Technical Bulletin

Model
911C2/C4

Subject: Rear Spoiler Gear Mounting Screws

Number
9104

Figure 1

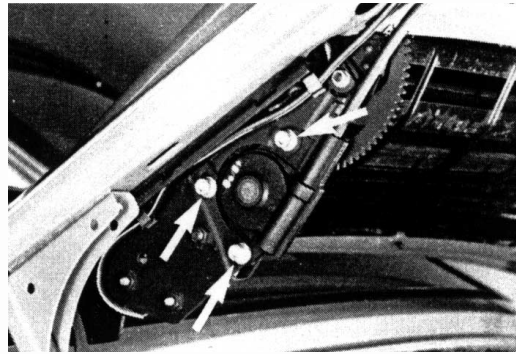
Concern: Undesired loosening of rear spoiler drive gear mounting screws (Figure 1).

Vehicle Information: Microencapsulated rear spoiler drive gear mounting screws are installed from production date: December 12, 1990.

Figure 2

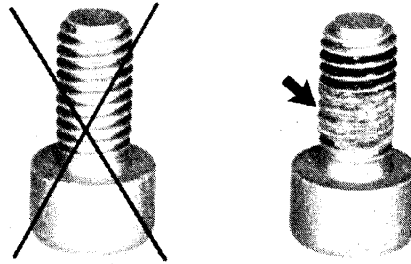
Service Information: When repairing loose spoiler drive gears on vehicles prior to the above VIN, microencapsulated mounting screws should be installed (arrow in Figure 2 on the following page).

Microencapsulated screw M6 x 12 Part Number N 014 701 7
(three required per car).
